P&Z STAFF REPORT

Board of Appeals Hearing; September 10, 2015

Case: **201502294 – 4666 E. Conway Drive**

Case: **201502244 – 339 Tara Trail**

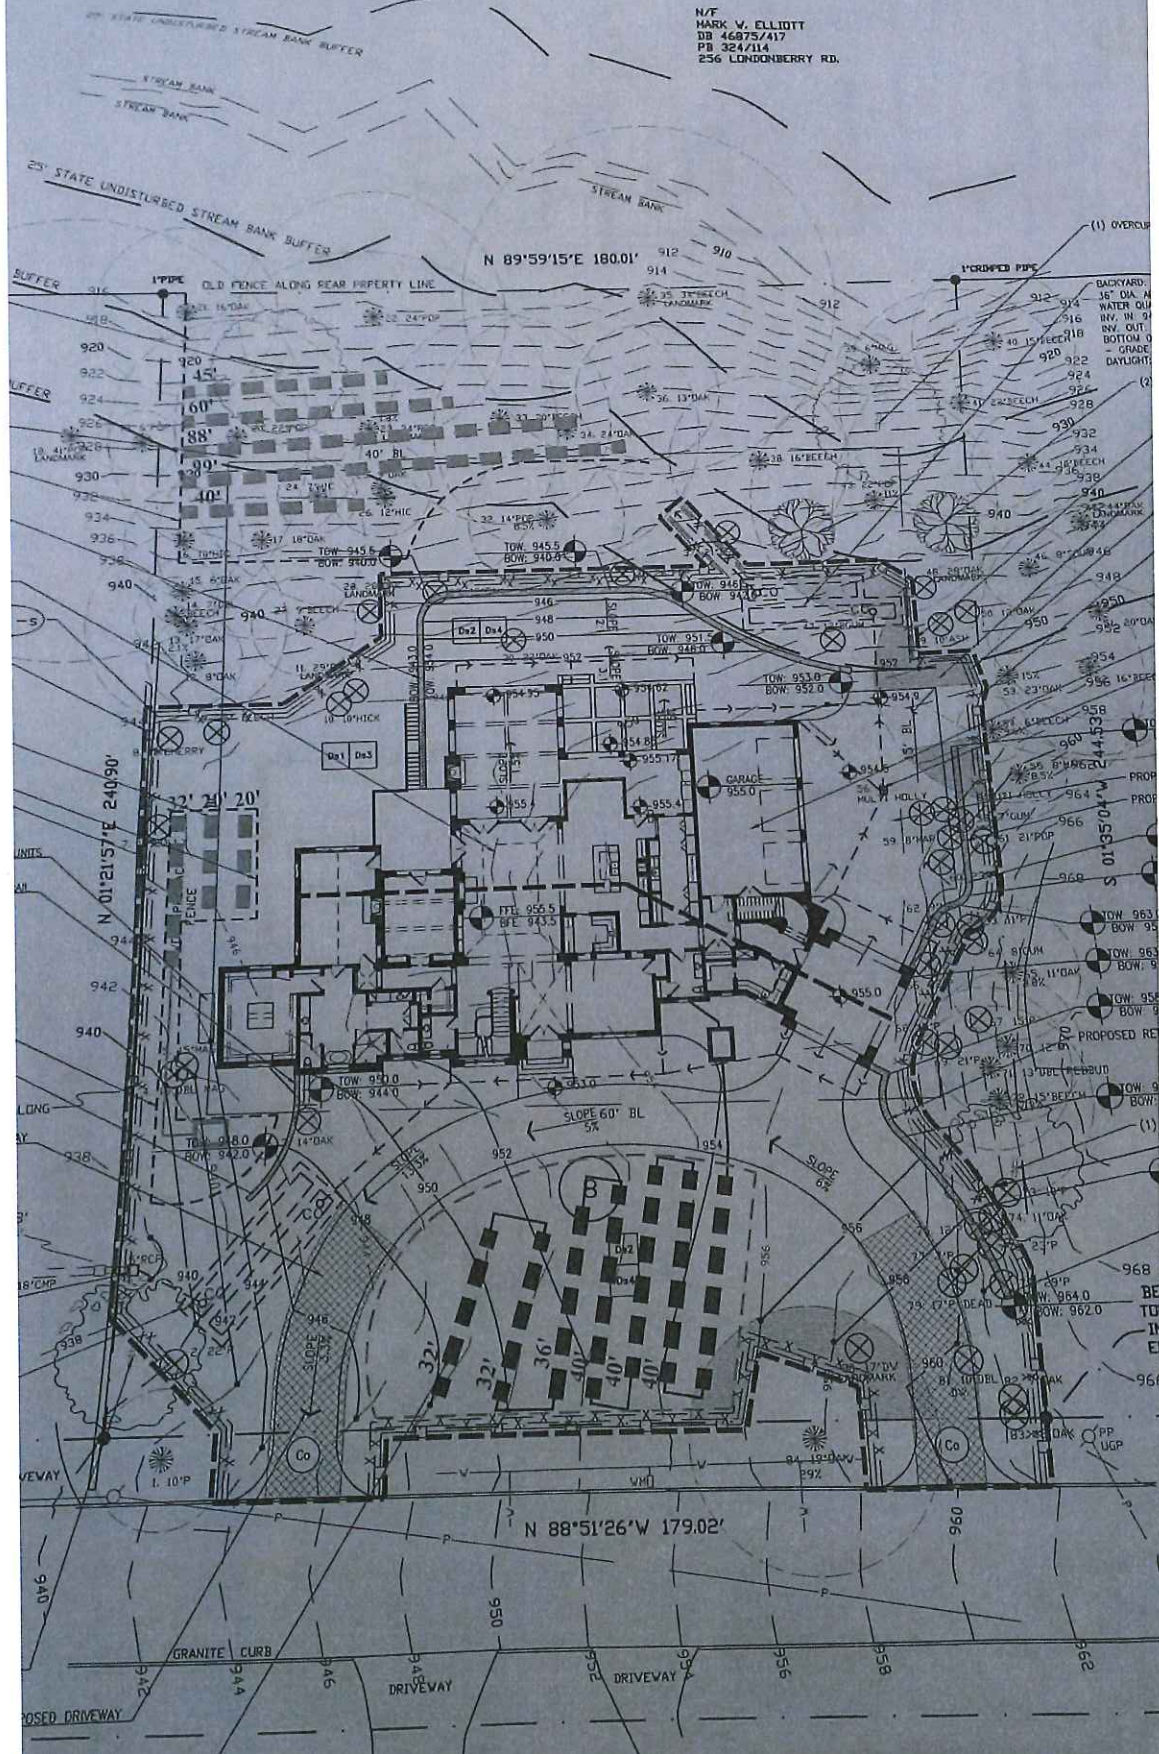
Finding: The applicant submitted a letter of intent stating the hardship is due to the steeply sloped topography in the rear yard between the proposed house and the fifty (50) foot undisturbed vegetative buffer and that the retaining wall is required to create a livable and marketable rear yard for the property. Building permits for the property (201502341 and 201502342) showed the proposed retaining wall outside of the stream buffers were submitted and approved in July. Submitting the building permits with the retaining walls outside of the stream buffers indicate that there is no dire hardship and the applicant was satisfied with the location of the proposed retaining wall (attached image labeled "Building Permit 201502341 & 201502342" depicts the first submittal before the permits were approved).

Staff has reviewed the request relative to the variance standards contained in Section 22.3.1 of the Sandy Springs Zoning Ordinance. Based upon this review, staff recommends **DENIAL** of variance request 201502244 to encroach into the twenty-five (25) foot impervious surface setback to construct a retaining wall.

SURVEY FOR
 JAMES KOSEK

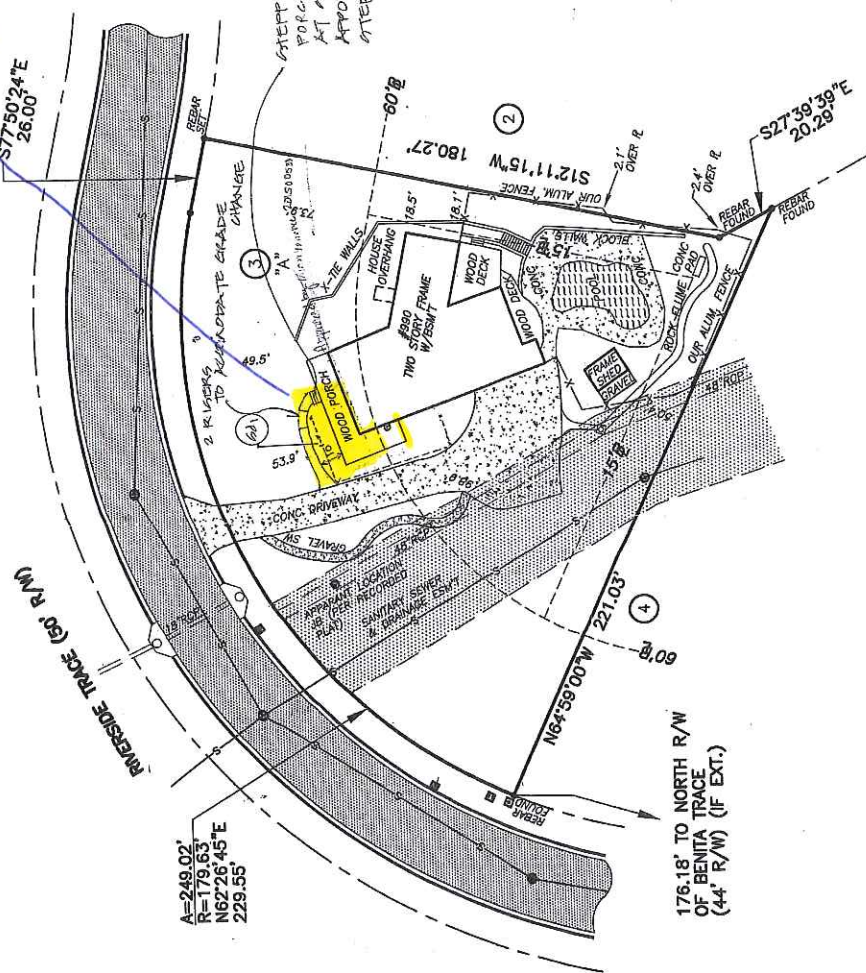
Finding: The existing house and existing porch encroaches into the minimum front yard by twenty (20) feet total. The dimension of the existing porch is 8'W x 16'L. The porch expansion is extended on the west and continues southward towards the required minimum front yard setback of sixty (60) feet. The porch expansion does not extend any further into the minimum front yard any more than the existing house and porch.

1. To allow an existing house, an existing porch, and proposed porch extension to encroach into the minimum front yard by twenty (20) feet, as shown on the site plan and design plan dated received July 6, 2015 by the Department of Community Development.
2. Any revisions of the submitted site plan must be reviewed and approved by Staff.
